DESIGN	AJS	DART AEROSPACE LTD HAWKESBURY, ONTARIO, CANADA	
DRAWN	AJS		
CHECKED	<i>[Signature]</i>	DRAWING NO.	REV. C
MFG. APPR.	N/A	DSI 9473	SHEET 8 OF 8
APPROVED	<i>[Signature]</i>	TITLE	SCALE
DE APPR.	<i>[Signature]</i>	AUTOMATIC LID OPENER INSTL	NTS
DATE	09.11.11	COPYRIGHT © 2009 BY DART AEROSPACE LTD THIS DOCUMENT IS PRIVATE AND CONFIDENTIAL AND IS SUPPLIED ON THE EXPRESS CONDITION THAT IT IS NOT TO BE USED FOR ANY PURPOSE OR COPIED OR COMMUNICATED TO ANY OTHER PERSON WITHOUT WRITTEN PERMISSION FROM DART AEROSPACE LTD.

DART SERVICE INSTRUCTION

TO AMEND DRAWING D350-607 REV. F OR SUBSEQUENT APPROVED REVISION

THE PURPOSE OF THIS DART SERVICE INSTRUCTION (DSI), IS TO PROVIDE OPERATORS OF AS350 / 355 ROTORCRAFT EQUIPPED WITH DART D350-607-041 HELI UTILITY BASKETS WITH AN UPGRADE KIT TO REPLACE THE EXISTING LID PROP ARM WITH 2 GAS SPRINGS.

VIEW F-F

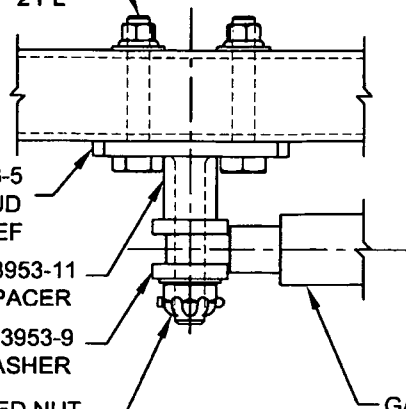
- 5) INSTALL 1X D3953-11 GAS SPRING SPACER ONTO THE D3953-5 STUD AS SHOWN IN VIEW F-F. INSTALL THE LARGE END OF THE D3969-1 GAS SPRING SPRING ONTO THE D3953-5 GAS SPRING STUD AND FASTEN IN PLACE USING 1X D3953-9 GAS SPRING WASHER, 1X NAS1149C0432R WASHER, 1X AN310-4 CASTELATTED NUT & 1X MS24665-212 COTTER PIN AS SHOWN IN VIEW F-F. INSTALL COTTER PIN PER MS33540 OR AC43.13 CHAPTER 7-127.

FIGURE 2
D350-607-143 AUTOMATIC LID OPENER INSTALLATION
 (1 END ONLY)

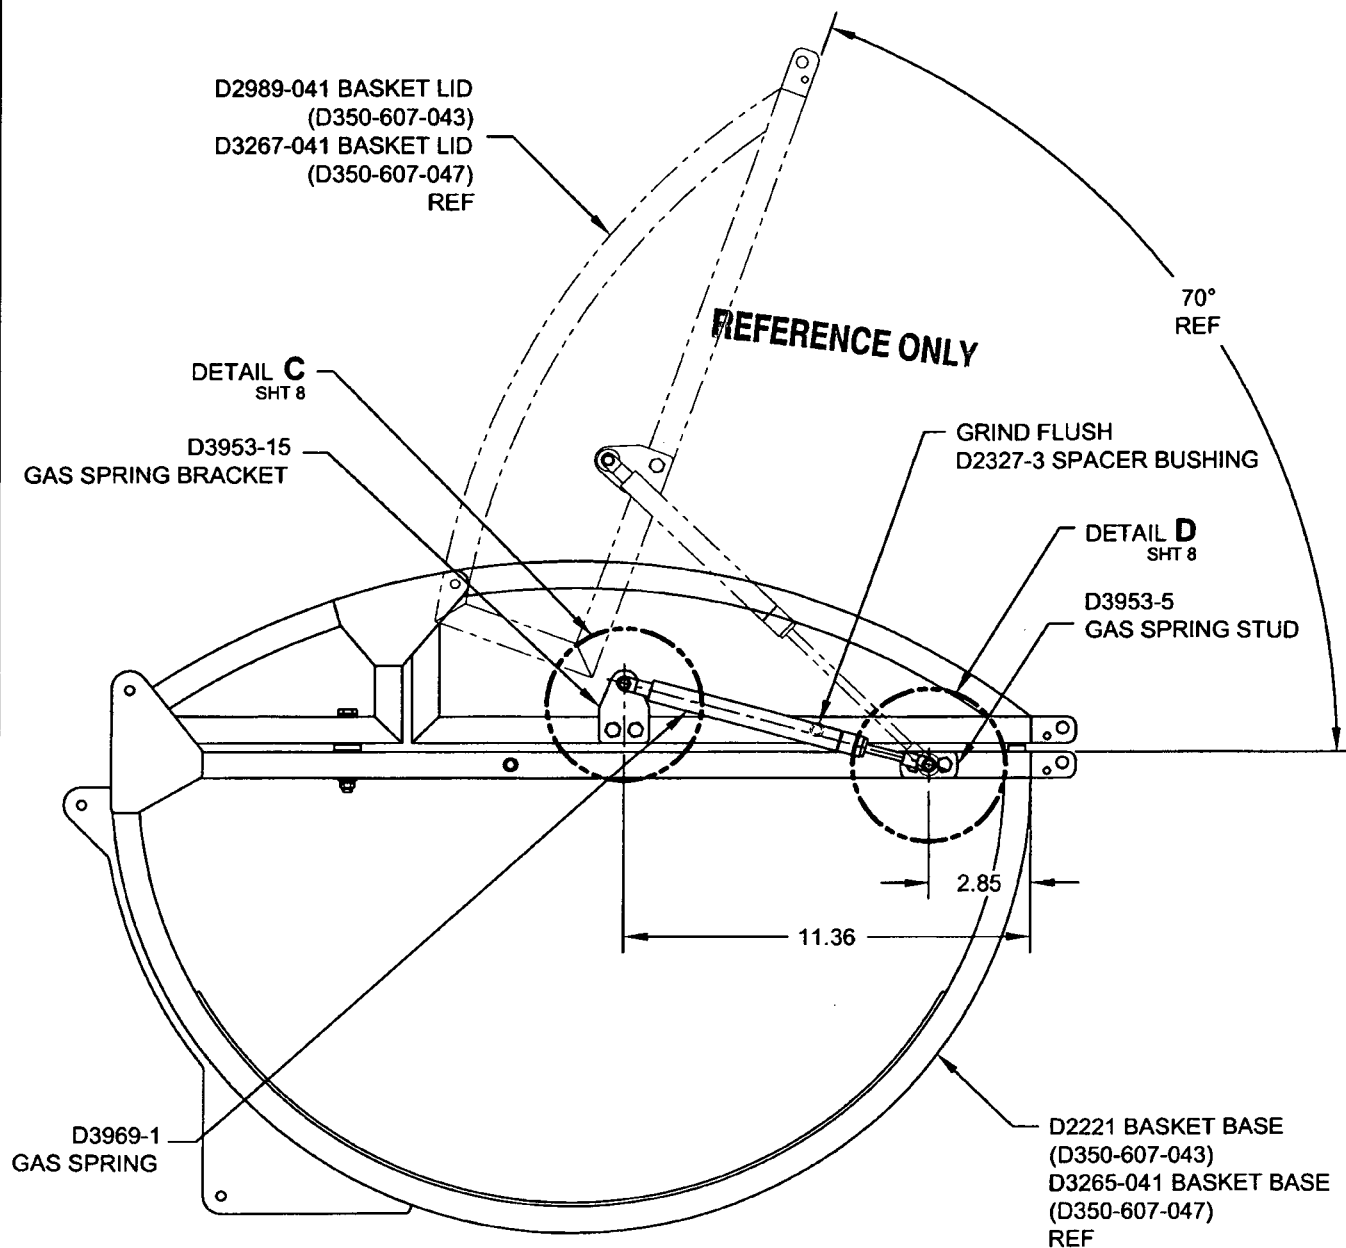
- 1) REMOVE THE D2332-041 PROP ARM.
- 2) GRIND FLUSH THE D2327-3 SPACER BUSHING ON THE END OF THE BASKET WHERE THE LID OPENER IS BE INSTALLED AS SHOWN IN FIGURE 2 (IT IS PERMISSIBLE TO GRIND ALL 4 SPACERS FLUSH). TOUCH UP PAINT PER ICA-D350-607 REV. 0 SECTION 5.1 ITEM 4.

- 3) LOCATE THE D3953-15 GAS SPRING BRACKET AS SHOWN IN FIGURE 2. TRIM STEEL MESH LOCALLY AS REQUIRED. TOUCH UP PAINT PER ICA-D350-607 REV. 0 SECTION 5.1 ITEM 4. TRANSFER MARK AND DRILL 2X Ø0.194 HOLES THRU THE BASKET LID SQUARE TUBE STRUCTURE AS SHOWN IN DETAIL C. INSTALL THE D3953-15 GAS SPRING BRACKET & D3953-17 GAS SPRING SPACER USING 2X AN3C15A BOLT, 2X NAS1149C0332R WASHER & 2X MS21043-3 NUT AS SHOWN IN VIEW G-G.

- 4) LOCATE THE D3953-5 GAS SPRING STUD AS SHOWN IN FIGURE 2. TRIM STEEL MESH LOCALLY AS REQUIRED. TOUCH UP PAINT PER ICA-D350-607 REV. 0 SECTION 5.1 ITEM 4. TRANSFER MARK AND DRILL 2X Ø0.194 HOLES THRU THE BASKET BASE SQUARE TUBE STRUCTURE AS SHOWN IN DETAIL D. INSTALL 2X AN3C11A BOLT, 2X NAS1149C0332R WASHER & 2X MS21043-3 NUT AS SHOWN IN VIEW H-H. INSTALL THE ROD END OF THE D3969-1 GAS SPRING ONTO THE D3953-3 GAS SPRING STUD USING 1X D3953-9 GAS SPRING WASHER, 1X NAS1149C0432R WASHER, 1X AN310-4 CASTELATTED NUT & 1X MS24665-212 COTTER PIN AS SHOWN IN VIEW H-H. INSTALL COTTER PIN PER MS33540 OR AC43.13 CHAPTER 7-127.

FIGURE 1

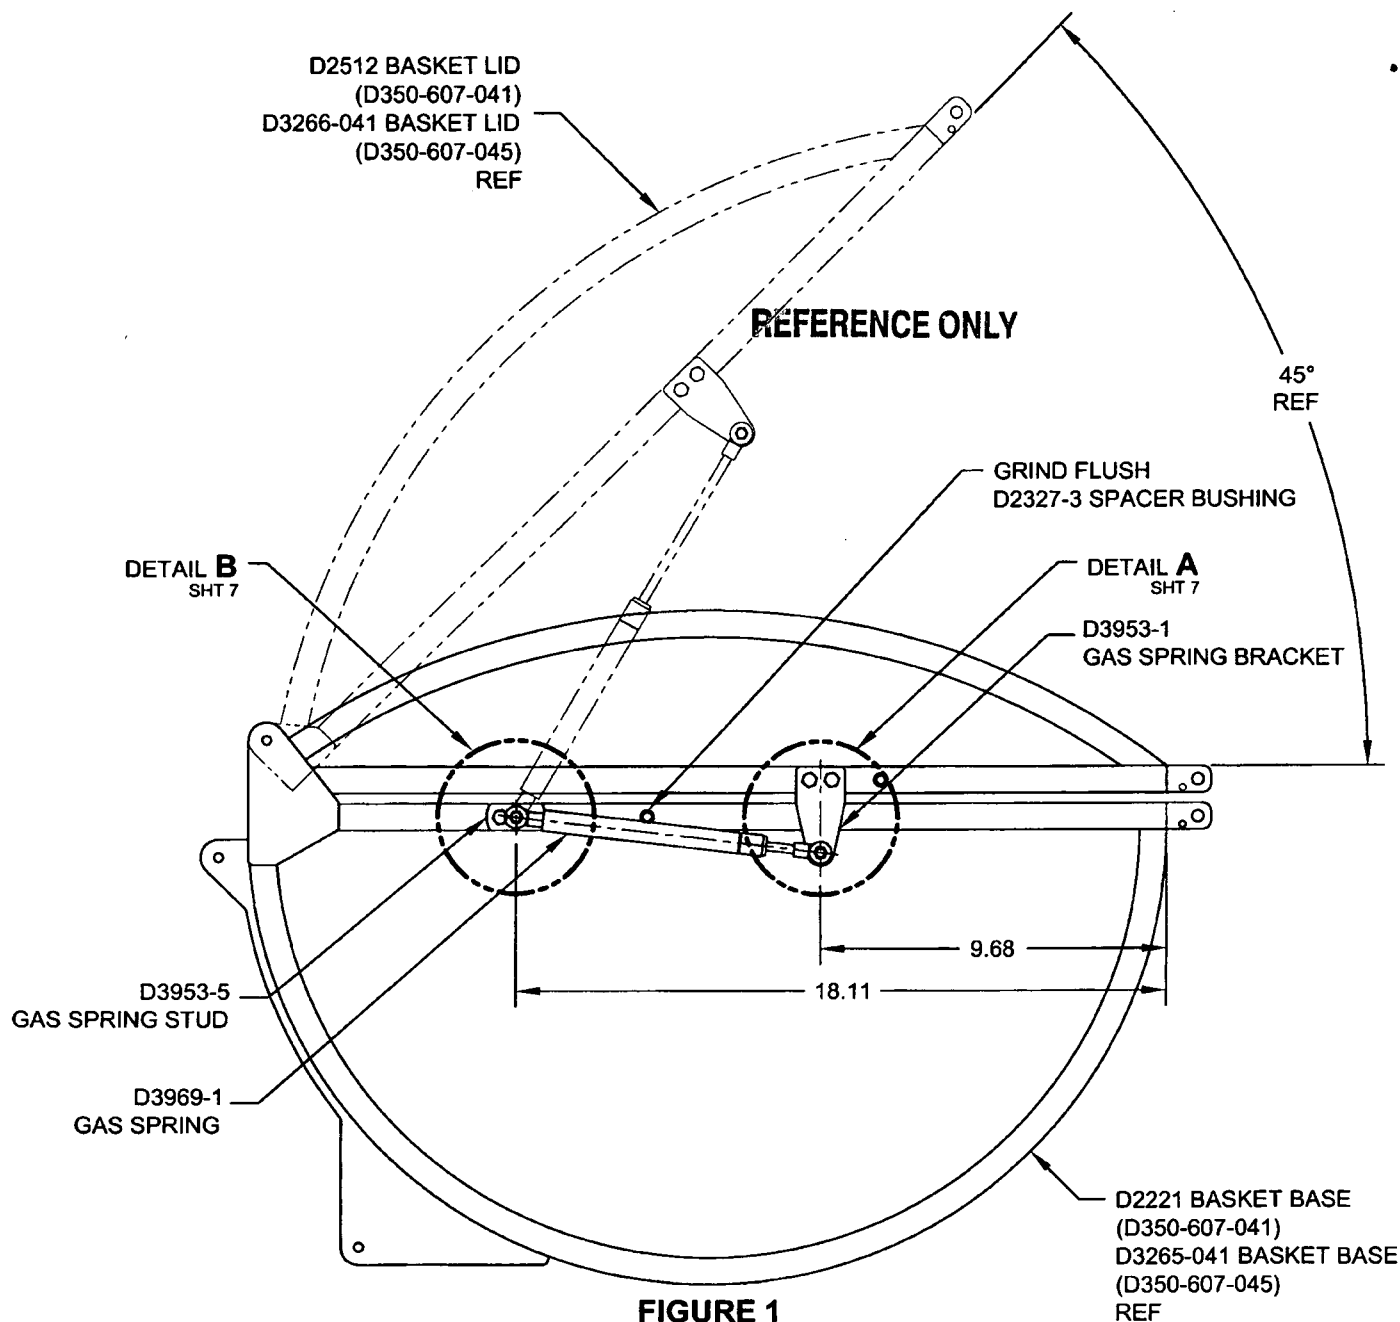
- 1) REMOVE THE D2332-041 PROP ARM.
 - 2) GRIND FLUSH THE D2327-3 SPACER BUSHING ON BOTH ENDS OF THE BASKET AS SHOWN IN FIGURE 1 (IT IS PERMISSIBLE TO GRIND ALL 4 SPACERS FLUSH). TOUCH UP PAINT PER ICA-D350-607 REV. 0 SECTION 5.1 ITEM 4.

- 3) LOCATE THE D3953-1 GAS SPRING BRACKET AS SHOWN IN FIGURE 1. TRIM STEEL MESH LOCALLY AS REQUIRED. TOUCH UP PAINT PER ICA-D350-607 REV. 0 SECTION 5.1 ITEM 4. TRANSFER MARK AND DRILL 2X Ø0.194 HOLES THRU THE BASKET LID SQUARE TUBE STRUCTURE AS SHOWN IN DETAIL A. INSTALL THE D3953-1 GAS SPRING BRACKET & D3953-13 GAS SPRING SPACER USING 2X AN3C16A BOLT, 2X NAS1149C0332R WASHER & 2X MS21043-3 NUT AS SHOWN IN VIEW E-E.

- 4) LOCATE THE D3953-5 GAS SPRING STUD AS SHOWN IN FIGURE 1. TRIM STEEL MESH LOCALLY AS REQUIRED. TOUCH UP PAINT PER ICA-D350-607 REV. 0 SECTION 5.1 ITEM 4. TRANSFER MARK AND DRILL 2X Ø0.194 HOLES THRU THE BASKET BASE SQUARE TUBE STRUCTURE AS SHOWN IN DETAIL B. FASTEN D3953-5 IAW VIEW F-F USING 2X AN3C11A BOLT, 2X NAS1149C0332R WASHER & 2X MS21043-3 NUT.
